IDAHO DEPARTMENT OF WATER RESOURCES
RECOMMENDATION OF WATER RIGHTS ACQUIRED UNDER STATE LAW

RIGHT NUMBER: 63-9804
NAME AND ADDRESS: STATE OF IDAHO
DEPT OF LANDS
300 N 6TH ST STE 103
PO BOX 83720
BOISE ID 83720-0050

IDL 61 & 63 Late claims update

#3

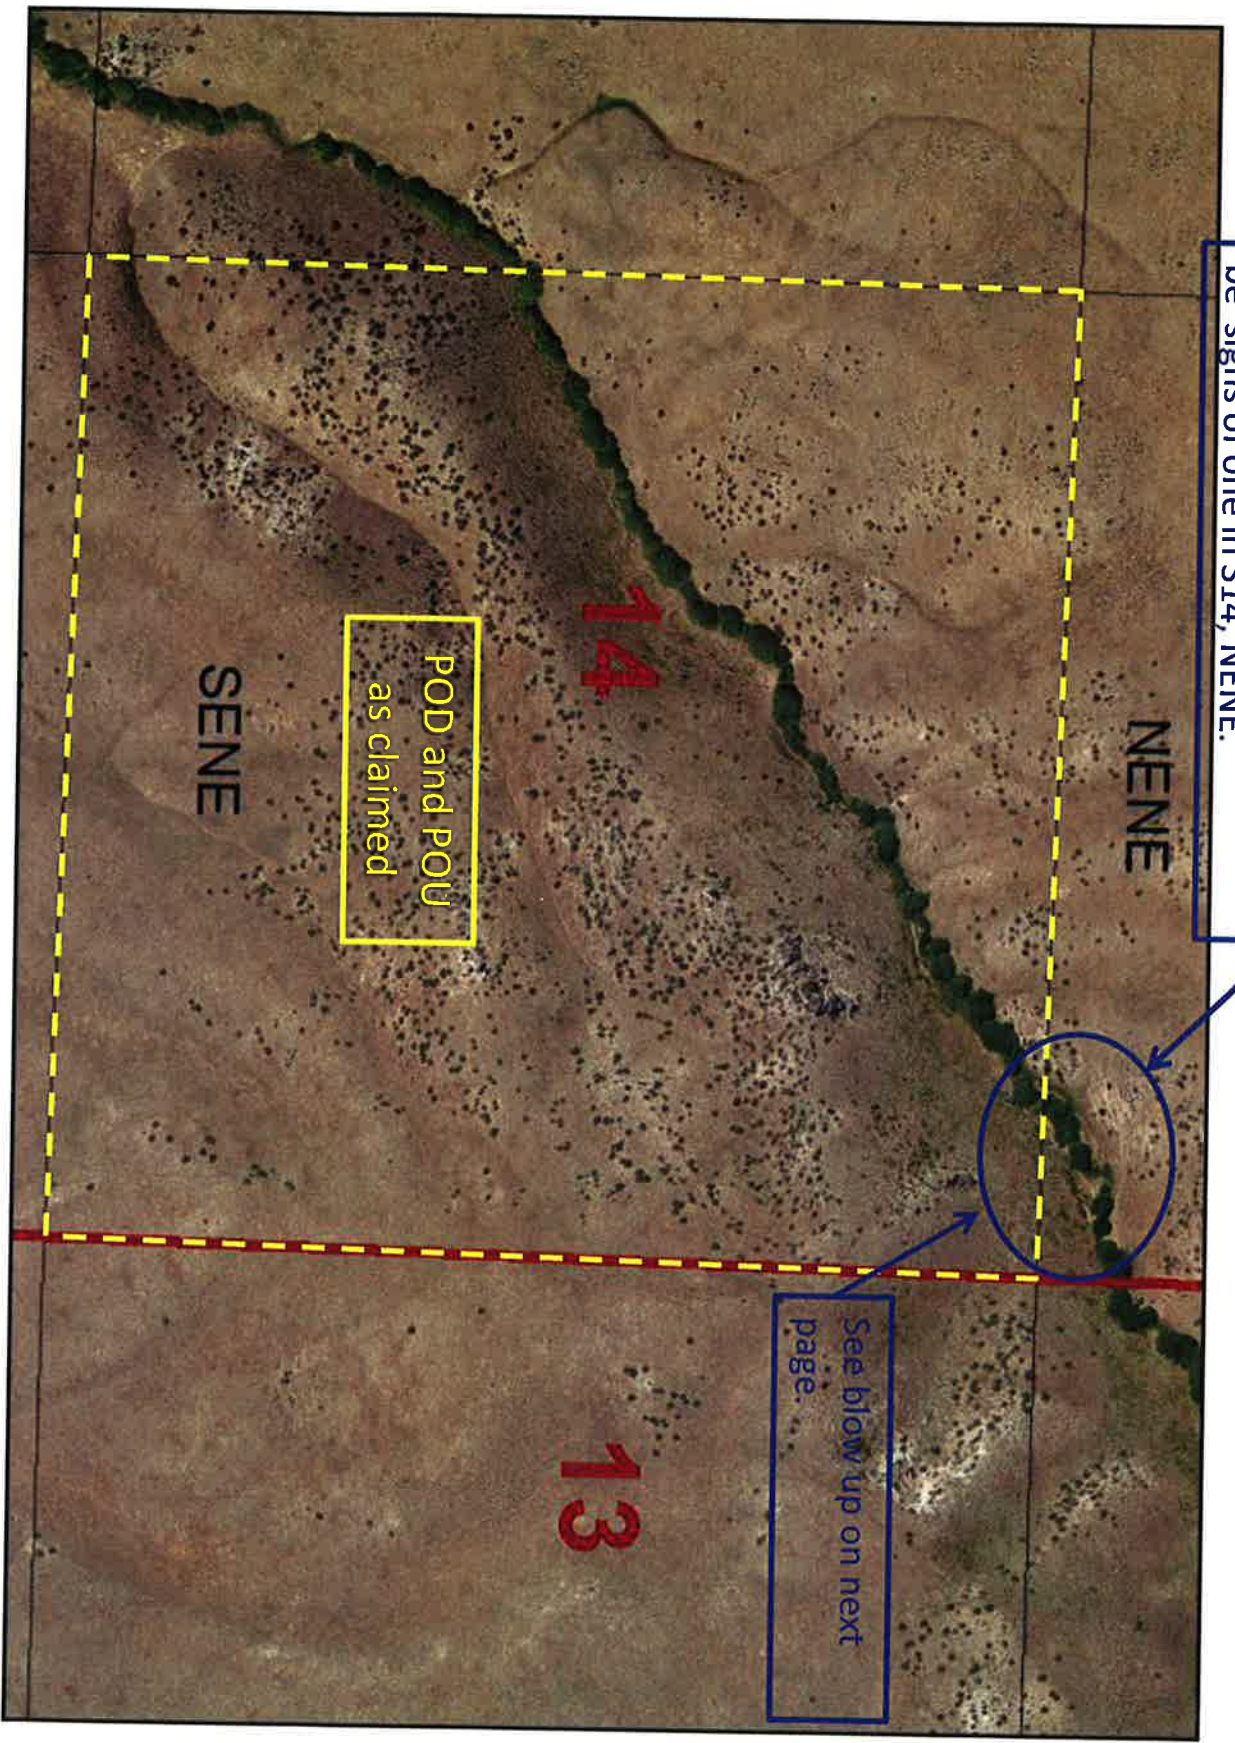
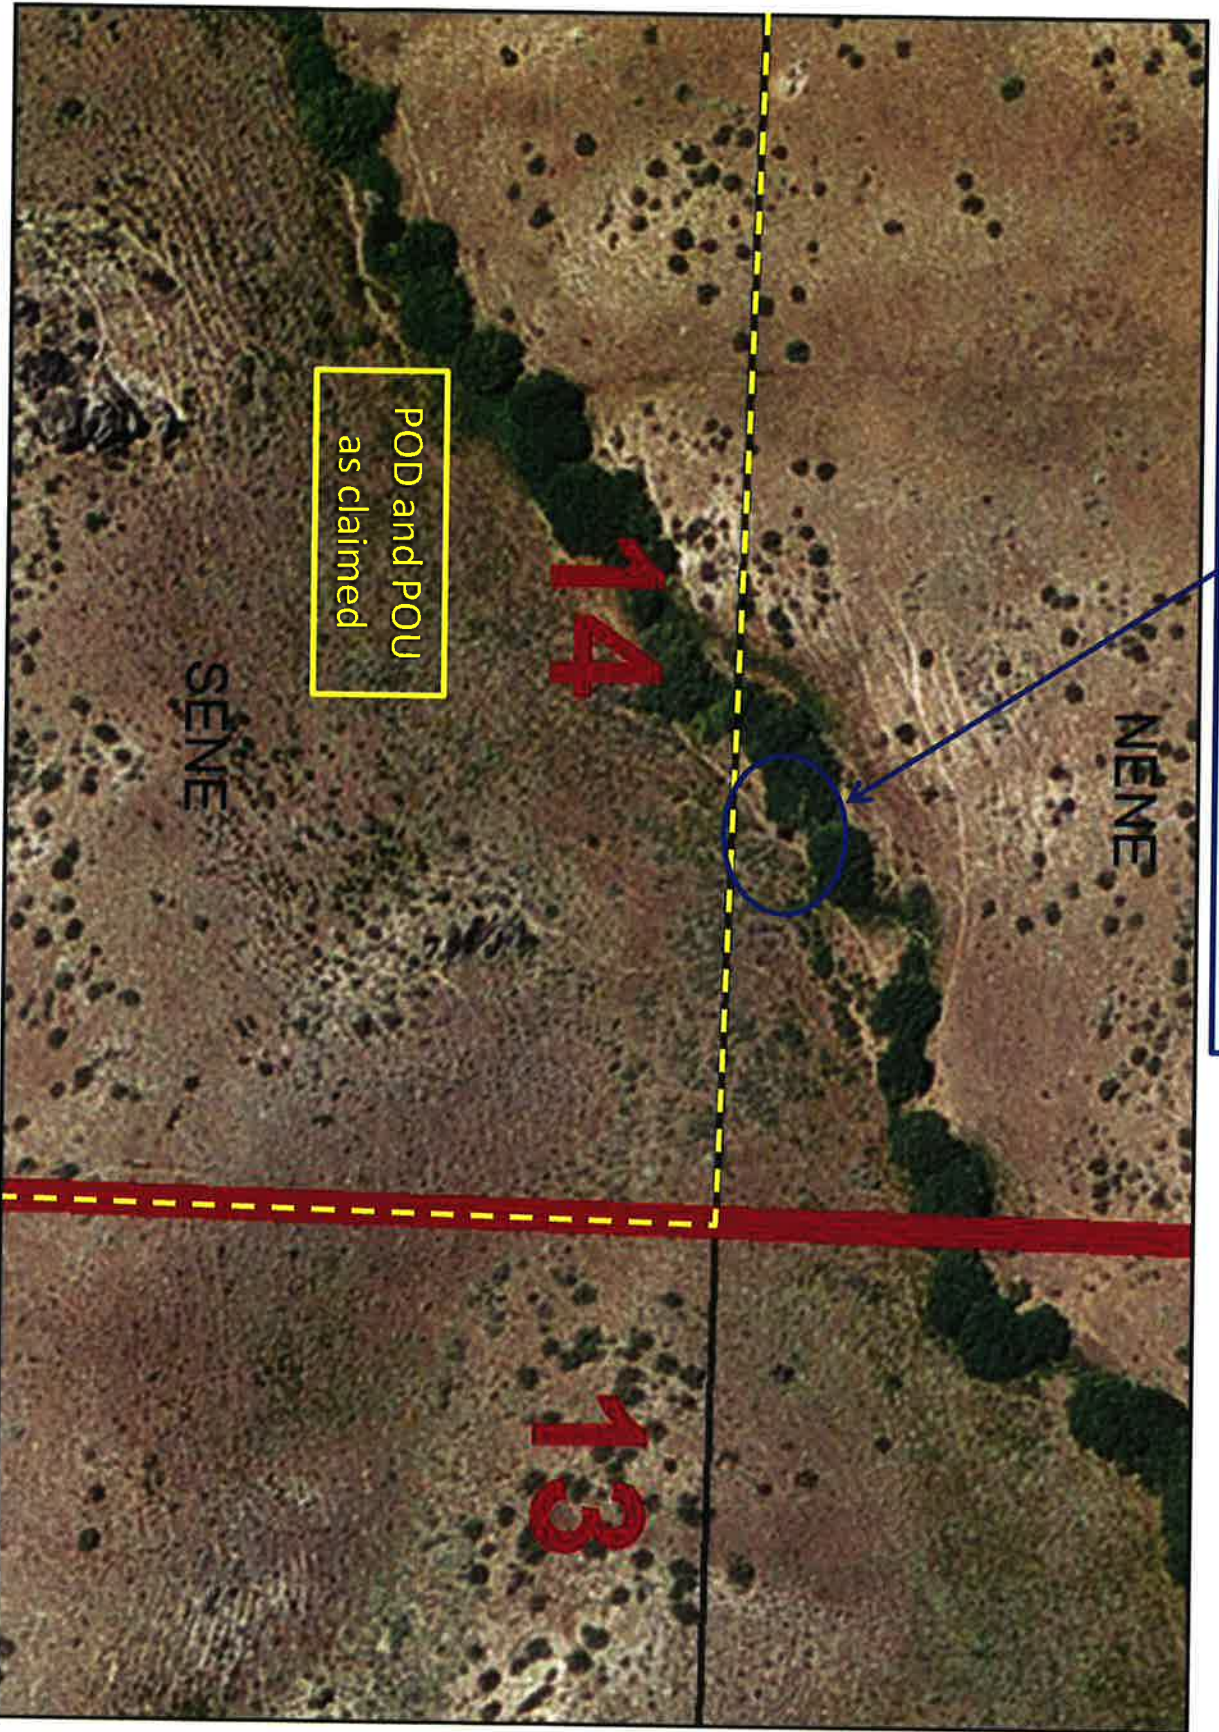
There are no signs of a trough or pond in S14, SENE. However there appears to be signs of one in S14, NENE.

Is this a trough or pond? If so, it appears that the POD and POU are actually located in NENE instead of SENE.
